Access Compliance Report Public Rights-of-Way (Curb Ramps)

Intersection ID: 42724Main Street: SPEEDWELL_CTCross Street: WAKEROBIN_LNLocation:SADA ID: 7C4FB348C3FBRamp Type: PerpDiagInitial Pass/Fail: FailOverall Compliance: NoSeverity Score:17.5

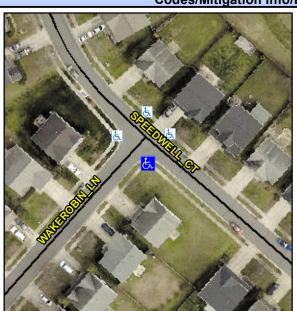
Not Found, R304.5.1

Compliance Description		Data	Compliance Description		Data
N/A	Ramp Length (in)	51.0	Yes	Ramp Slope (%)	6.9
No	Ramp Width (in)	35.0	Yes	Ramp XSlope (%)	1.9
N/A	Flare Type LT	N/A	N/A	Flare Type RT	N/A
N/A	Flare Slope LT (%)	N/A	N/A	Flare Slope RT (%)	N/A
N/A	Flare Traversable LT?	N/A	N/A	Flare Traversable RT?	N/A
N/A	Landing Length (in)	N/A	N/A	DWS Provided?	N/A
N/A	Landing Width (in)	N/A	N/A	DWS Contrast?	N/A
N/A	Landing Slope (%)	N/A	N/A	DWS Length (in)	N/A
N/A	Landing X Slope (%)	N/A	N/A	DWS Full Width?	N/A
N/A	Landing Curb? (Y/N)	N/A	N/A	DWS Offset (in)	N/A
N/A	Shared Landing?	N/A			
N/A	Gutter Ponding?	N/A	N/A	Gutter Slope (%)	N/A
N/A	Gutter Lip Ht (in)	N/A	N/A	Gutter X Slope (%)	N/A
N/A	Painted X Walk1?	No	N/A	Painted X Walk2?	No
	X Walk 1 Direction	To NE		X Walk 2 Direction	To NW
N/A	X Walk 1 Width (in)	N/A	N/A	X Walk 2 Width (in)	N/A
	X Walk 1 Slope (%)	5.7		X Walk 2 Slope (%)	6.8
	X Walk 1 X Slope (%)	4.1		X Walk 2 X Slope (%)	0.5

Remove & Replace Curb Ramp With
Two New Directional Ramps or
Equivalent.
